UNITED STATES PATENT AND TRADEMARK OFFICE

APPLICATION NO.	FILING DATE	FIRST NAMED INVENTOR	ATTORNEY DOCKET NO.	CONFIRMATION NO.
10/753,874	01/09/2004	Hans Joachim Halamoda	7863-80940	6117

Office Action Summary

DETAILED ACTION

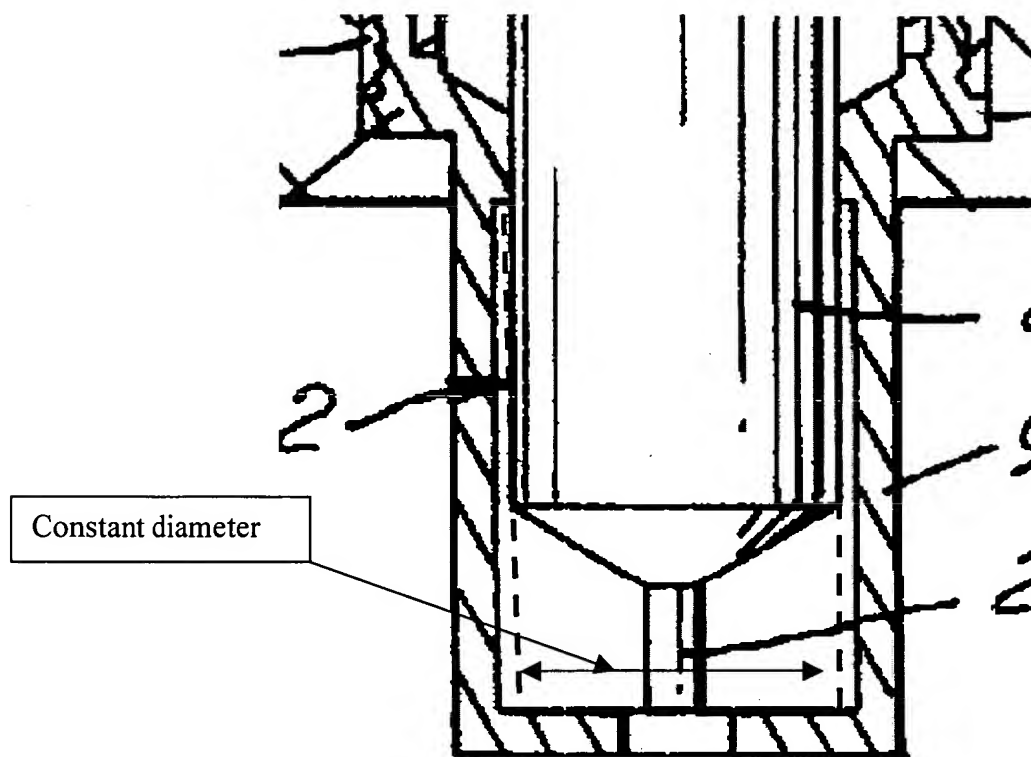
The Applicant argues that it is not clear where in the Cotter's punching device the constant diameter stripper opening would be located. The location of device the constant diameter stripper opening will be explained in the following paragraph.

Liander teaches the punch head 18 and the punch head support (the lower end of element 16) of the punch head being guided in a constant diameter stripper opening. Cotter teaches the punch head 26 and the punch head support 28 being guided in a non-constant diameter stripper opening 93'. In order to make the diameter of the stripper opening 93' constant, the upper diameter of the stripper opening 93' extends down to the bottom surface of the stripper opening 93'. See the below sketch.
